Airworthiness Directive Schedule

Components & Equipment

Aircraft Seats and Harnesses

24 June 2021

DCA/SEAT/6 Safety Belt Assemblies - Removal

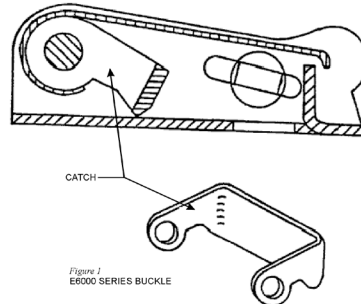
Requirement: To prevent inadvertent opening of safety belt assemblies accomplish the following:

1. Inspect all Eon Corporation TSO C22 safety belt assemblies for incorporation of E6000 buckles.
2. Remove from service all safety belt assemblies with E6000 buckles and replace with approved safety belt assemblies. Removed belts, if not destroyed, must have the TSO approval markings either permanently obliterated or removed.

Note: Buckle assembly concerned has a front cover plate which is pivoted at one end and is pulled through an arc at the other end to release the latch from the buckle. The E6000 buckle can be identified by the type of catch used. Figure 1 (following) shows the catch configuration and its location within the buckle assembly.

DCA/SEAT/10 Aircraft Belts Inc – Inspection and Replacement

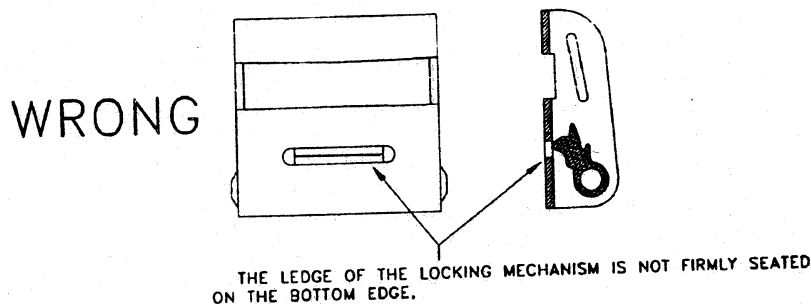
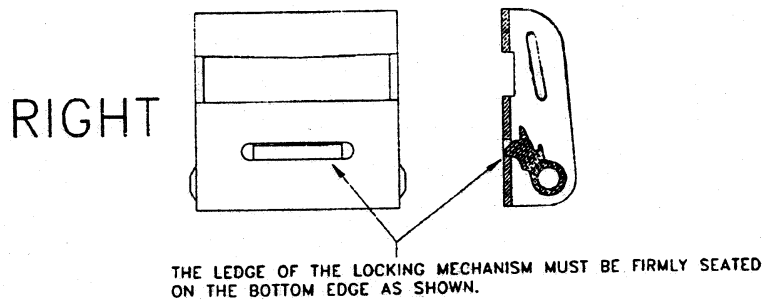
Visually inspect all affected seat restraint systems to determine if the locking mechanism is engaging properly per the following:

Open the lift lever of the buckle fully until it will not open any further. This will cause the locking mechanism to pivot on the pivot pin.

Allow the spring to close the lift lever slowly until the lift lever is back to its at-rest position.

After the lever is completely closed, examine the slot in the bottom of the buckle. The locking mechanism should be firmly seated against the edge of the slot as shown in Figure 1.

If the locking mechanism does not seat properly, replace the buckle with an airworthy buckle.
